ECE/TRANS/WP.29/GRSG/2008/3  
30 January 2008

REGULATION No. 46  
(Devices for indirect vision)

Proposed amendments to the Regulation

Submitted by the expert from the Netherlands<sup>\*/</sup>

**Figure 1** Diagram of the blooming measurement set-up. 1: Black & white background. 2: Lamps to make the background evenly illuminated. 3: Mirror. 4: high intensity light. 5: Camera. 6: Monitor.

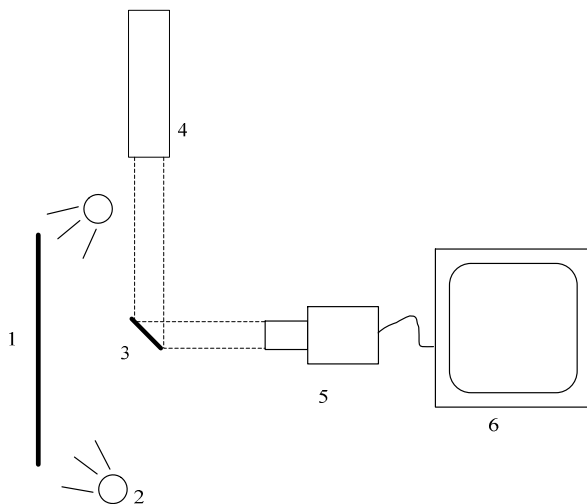
**Test for the determination of the saturated area of the camera under the conditions mentioned in paragraph 6.2.2.2.1**

A high-intensity light (e.g., theatre spotlight) is reflected into the image using a small mirror (see Figure 1). The illuminance of the camera by the light reflected from the mirror shall be 40,000 lx. The light source is depicted in the centre of the camera: the light enters the camera from the normal direction. A high contrast black and white pattern (e.g. a checkerboard pattern) is illuminated by a set of lamps to create an even illumination of 3000 ( $\pm 25\%$ ) lx.

The glare source should extend an angle (diameter) of  $5^\circ$  ( $\pm 10\%$ ). A schematic drawing of the set-up is given in Figure 1.

The mirror shall be placed such that its image is positioned in the middle of the pattern. The luminance contrast between the white and black areas in the display image can be

measured. The saturated area is defined by the area in which the contrast of a high contrast test pattern falls below 0.2. The contrast ( $C$ ) is defined by the difference in luminance between the bright ( $L_w$ ) and dark ( $L_b$ ; black) and regions divided by the luminance of the bright (white) regions:

The saturated area shall not cover more than 10% of the display area.

This new annex contains a detailed measuring set-up for the test in which low sunlight falling on the camera is simulated.

**Figure 2 Typical relationship between the size of the triangle and the fraction of correct responses.**

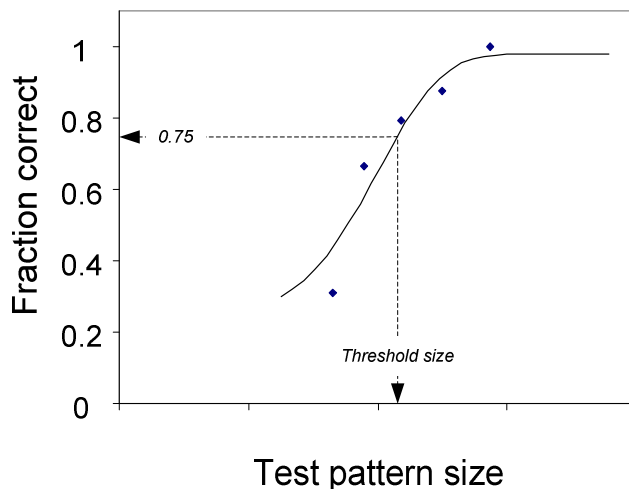
The TNO Landolt C test can be used to determine the smallest discernable detail of the camera-monitor system. However, for sensor systems it is more suitable to use the TOD (Triangle Orientation Discrimination) method which is similar to the Landolt C method, but involves equilateral triangular test patterns. The Triangle Orientation Discrimination method is described in detail by Bijl & Valeton (1999), who provide practical guidelines on how to perform a TOD measurement. In the method, triangular test patterns (see Figure 1) are viewed through the viewing system under test. Each triangle can have one out of four possible orientations (apex up, left, right or down) and the observer indicates/guesses for each triangle its orientation. When this procedure is repeated for many (randomly oriented) triangles of different sizes the fraction of correct responses can be plotted (see Figure 2), and increases with test pattern size. The threshold is defined as the point at which the fraction correct crosses the 0.75 level and can be obtained by fitting a smooth function through the data (see Bijl & Valeton, 1999). Critical perception is reached when the critical object diameter equals two times the width of the triangle at threshold size. The smallest discernable detail ( $\omega_c$ ) is equal to 0.25 times the width of the triangle at threshold size.

The procedure for calculating the maximum detection distance on the basis of video lines has been replaced by a new procedure based on ophthalmologic tests like Landolt-C or TOD (Triangle Orientation Discrimination).
